ADDENDUM NUMBER 02 TO THE BID DOCUMENTS

**BID DOCUMENT: 17/18 MB7
I21-35617 - Organic Farm Classrooms
College of Marin – Indian Valley Campus**

Addendum Date: 23 February 2018

A2.11

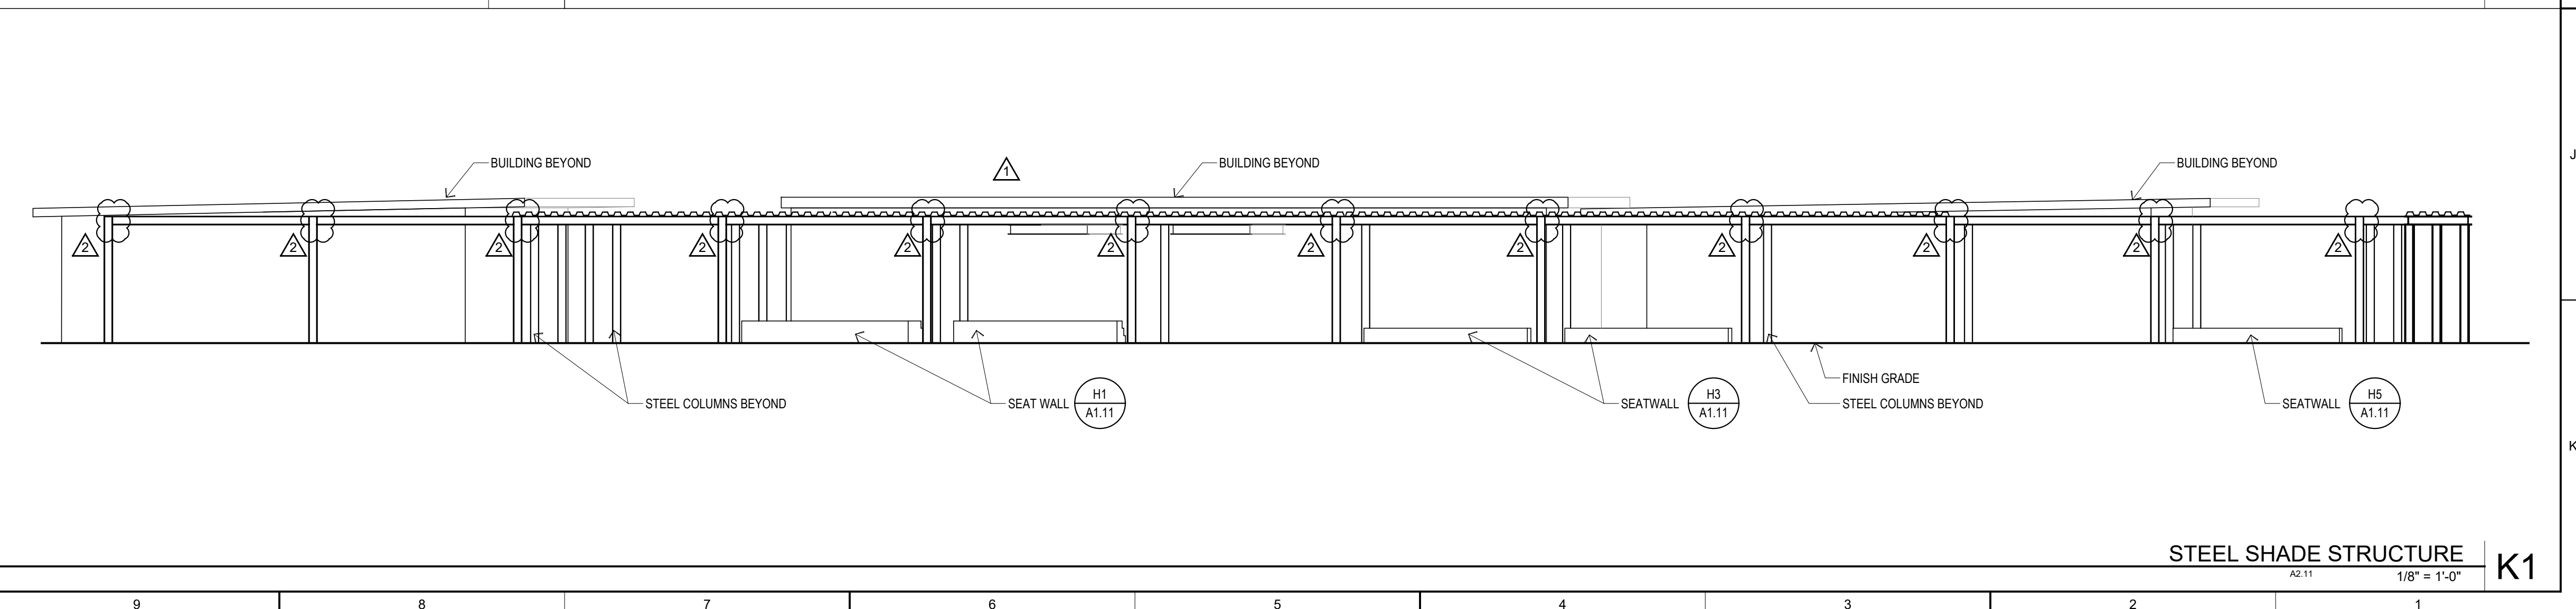
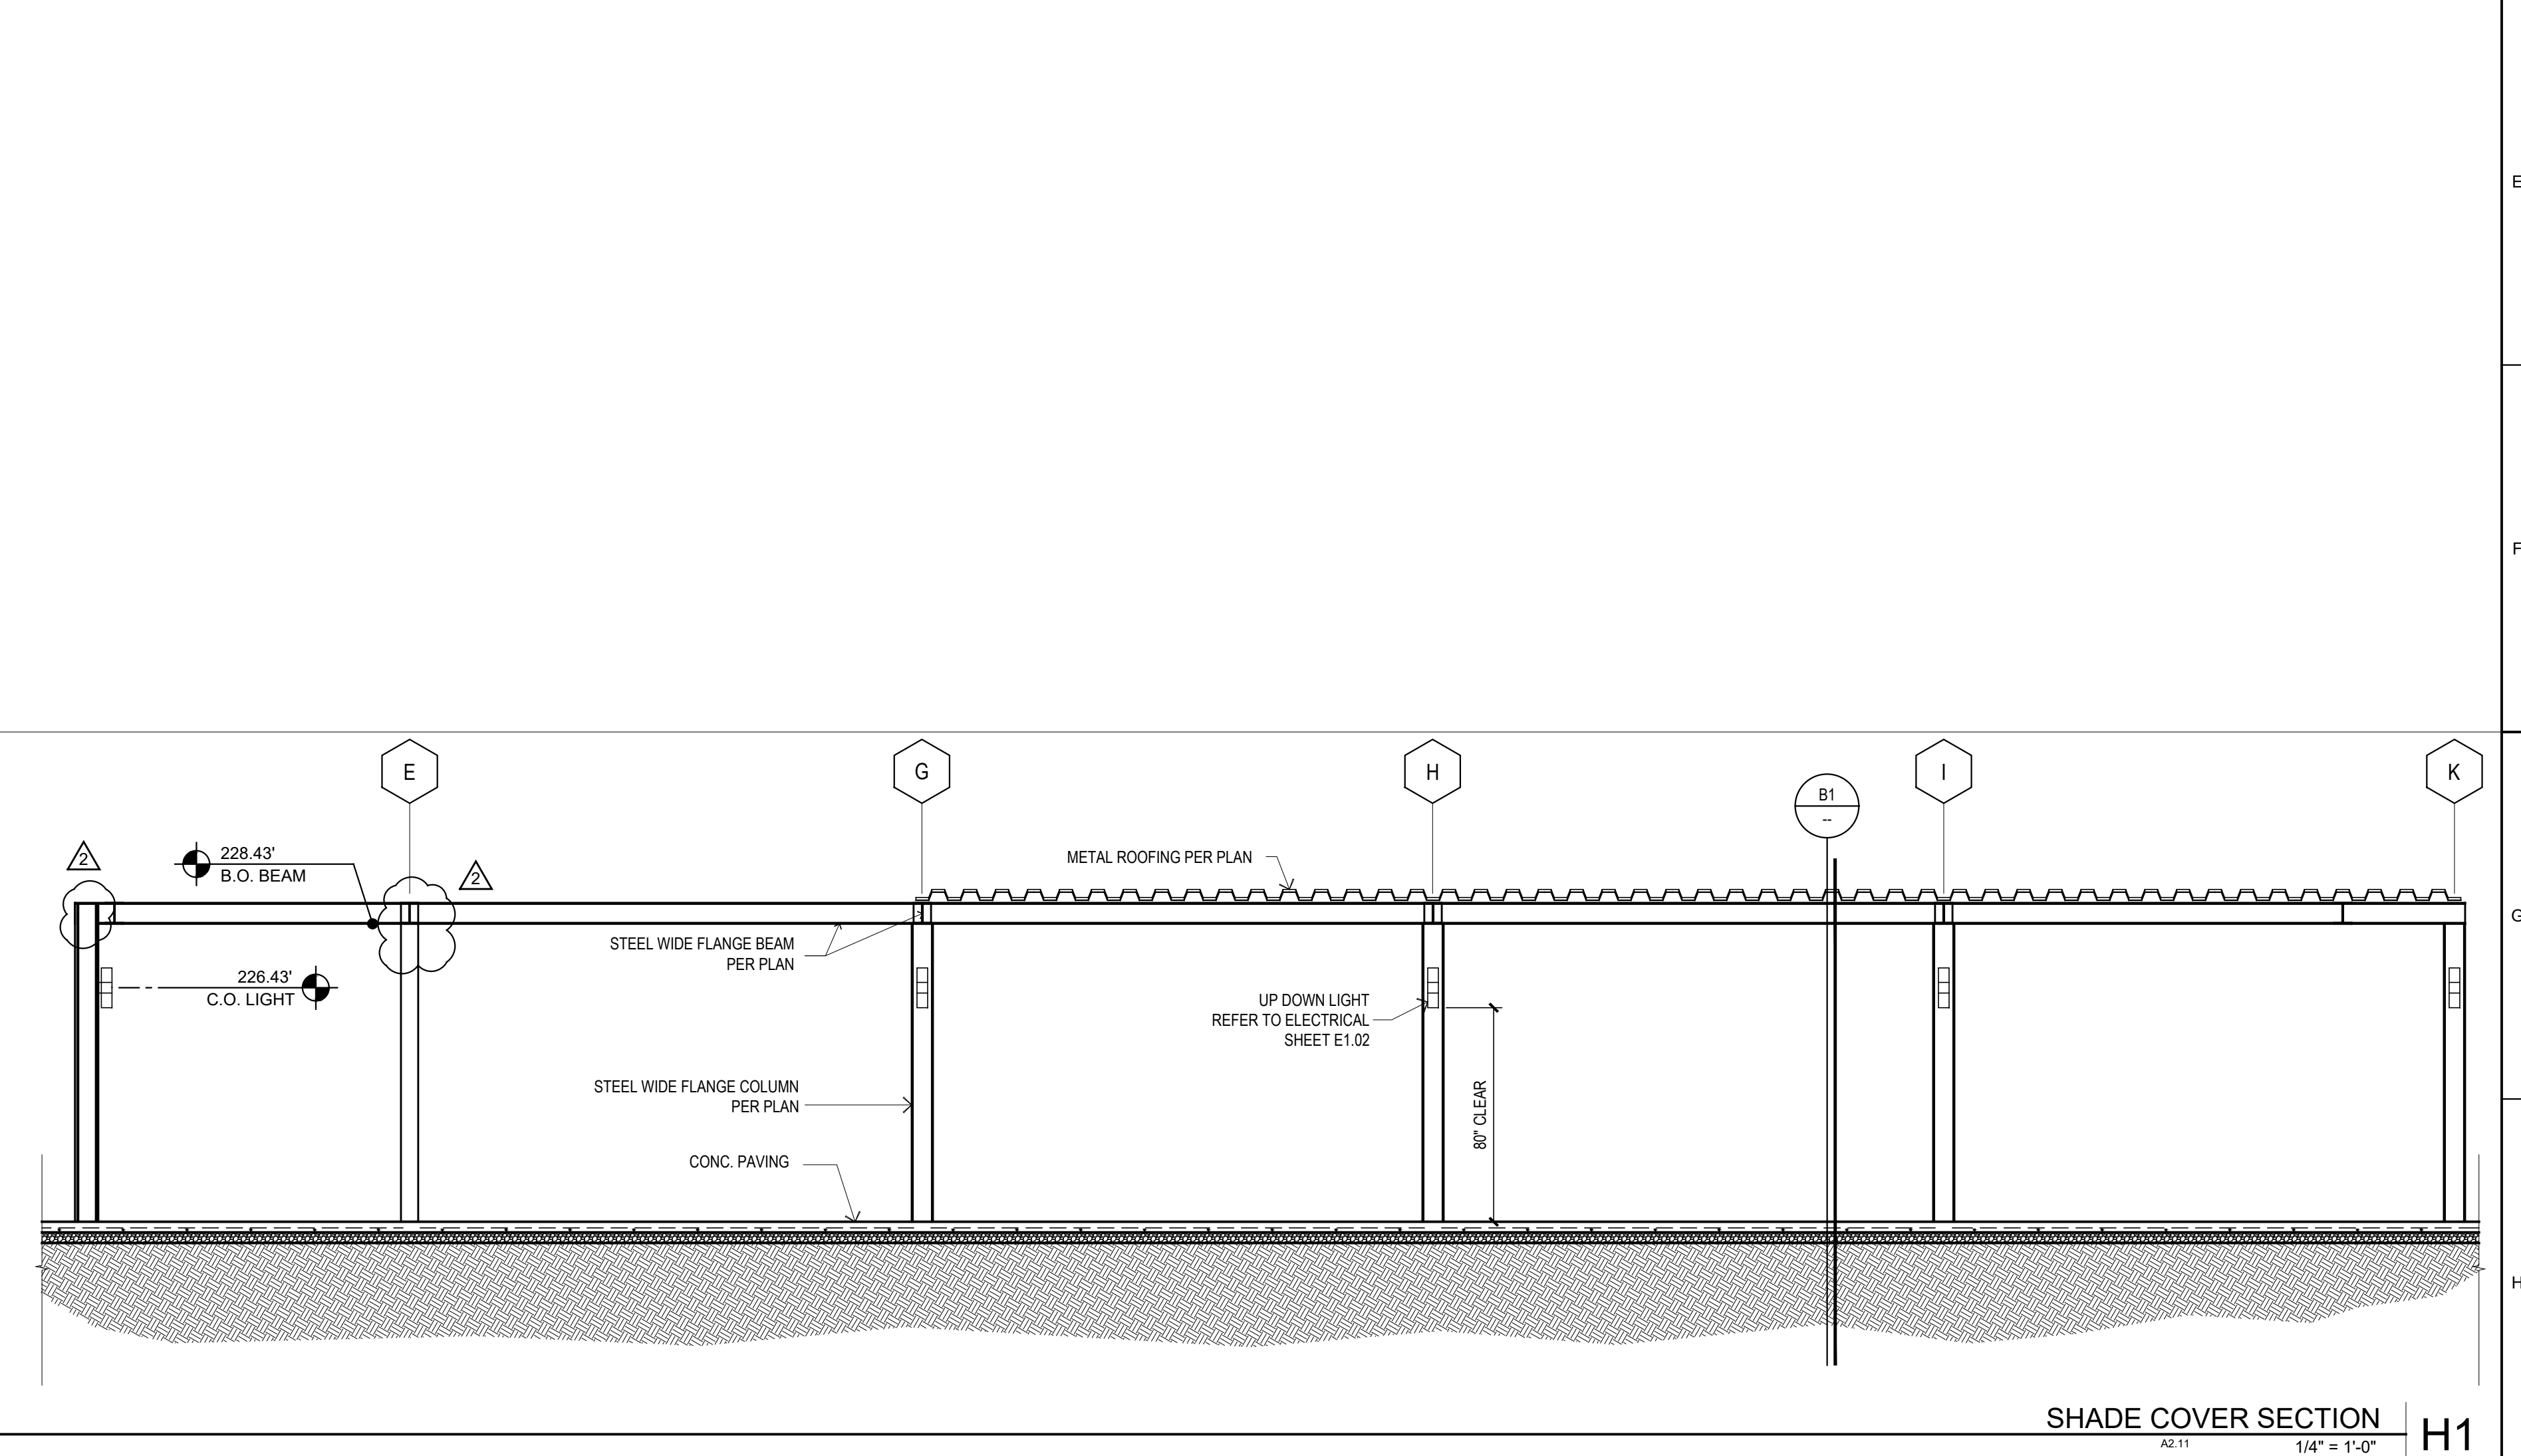
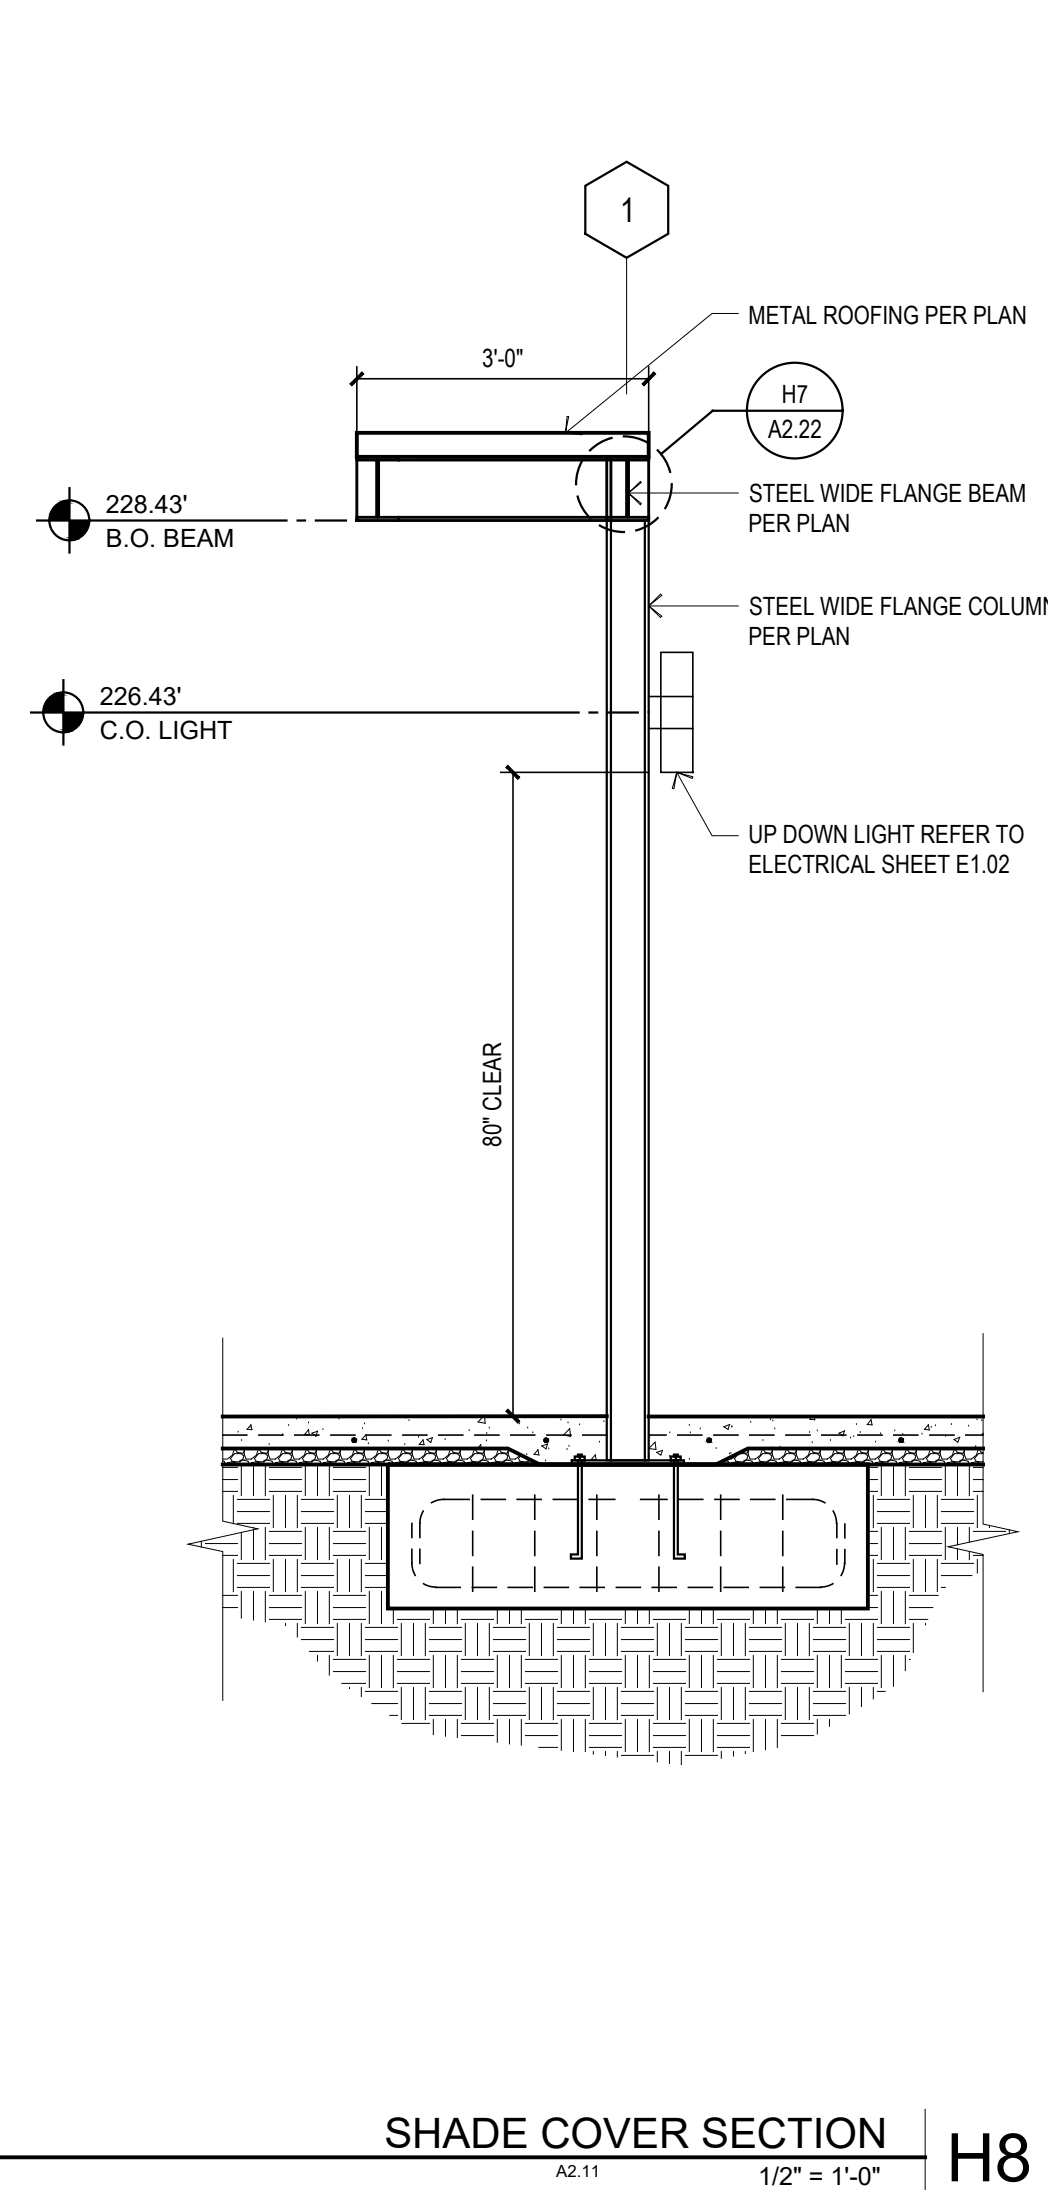
- Reinstate DSA approved comments.

A2.22

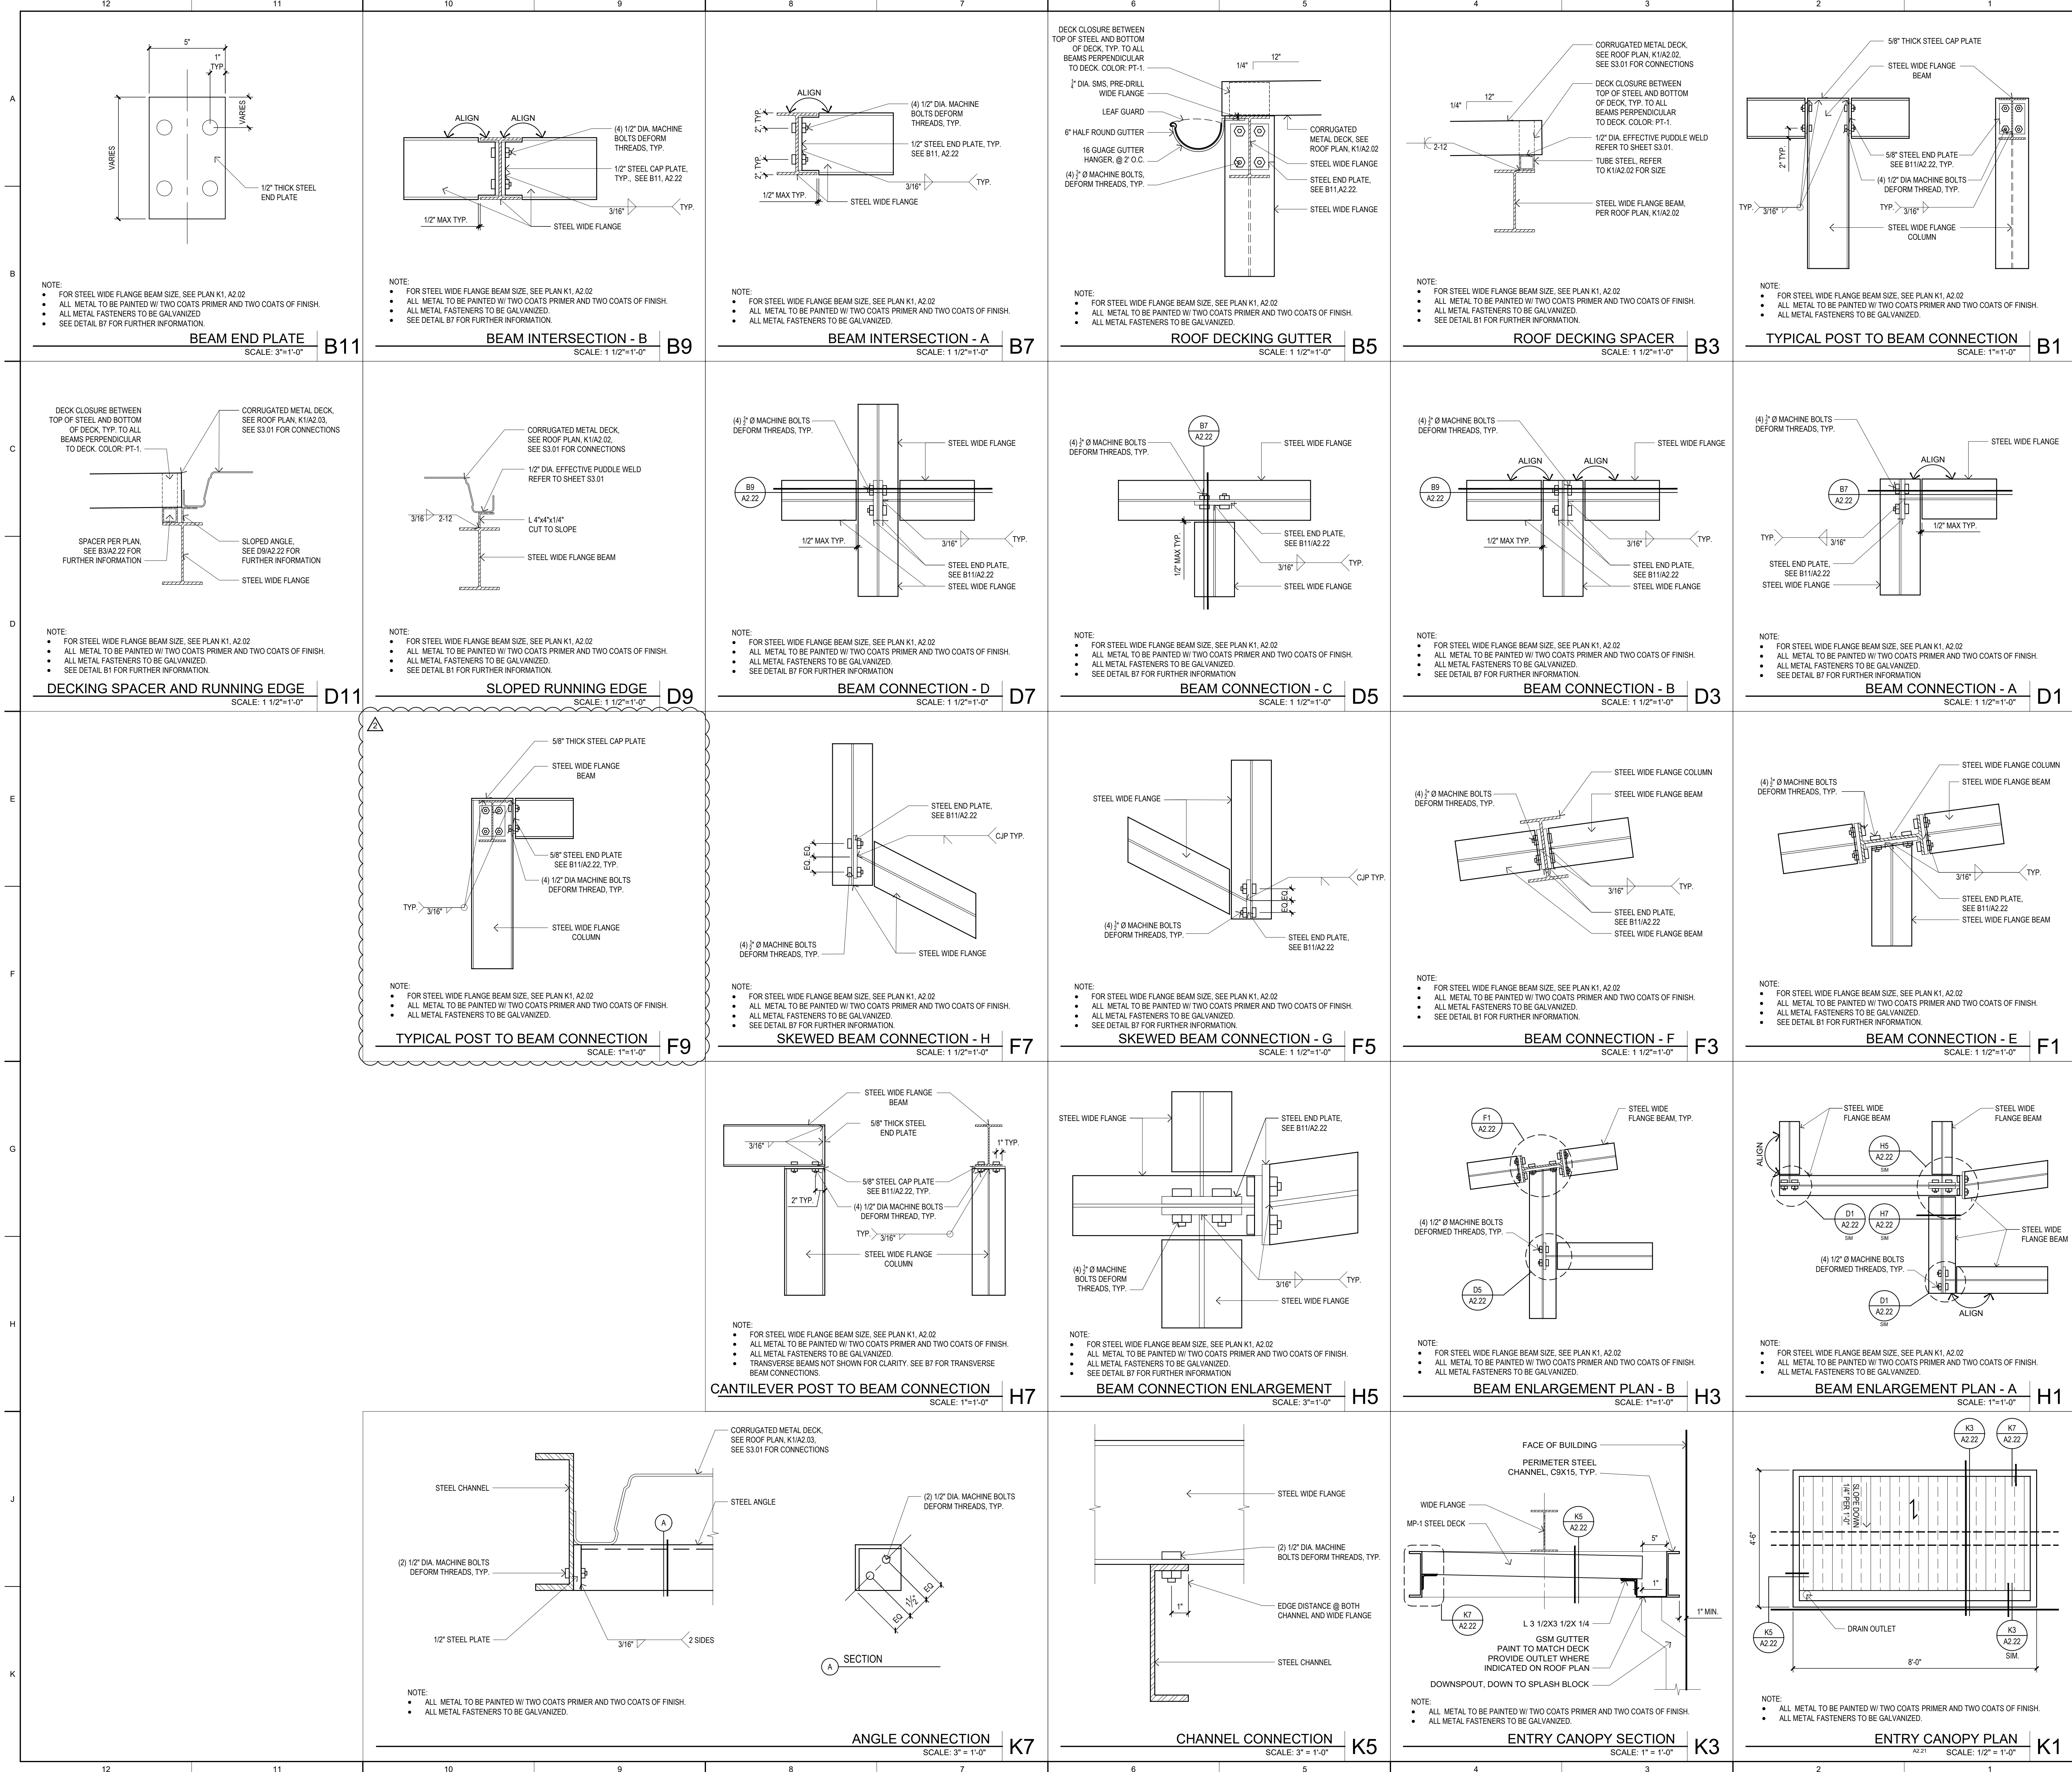
- Reinstate DSA approved comments, Detail F9.
